Q1. Why is Xilinx standardizing to 10-layer for Virtex-5 packages with more than 1000 pins?

Q2. What are the differences between the 8-layer and 10-layer packages?

XTP027_01_061009

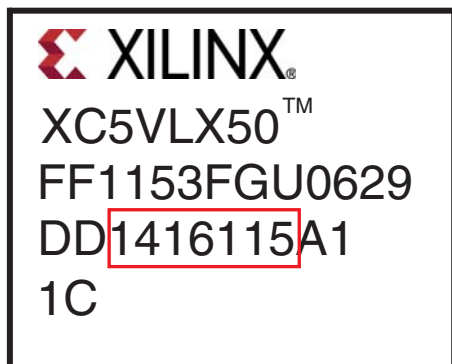
A. To trace the packages in your possession, please contact Xilinx Customer Service at csgroup@xilinx.com, and provide the 7- digit Lot ID (see example top mark below). Xilinx Customer Service can identify if the order was shipped with 8-layer or 10-layer packages.
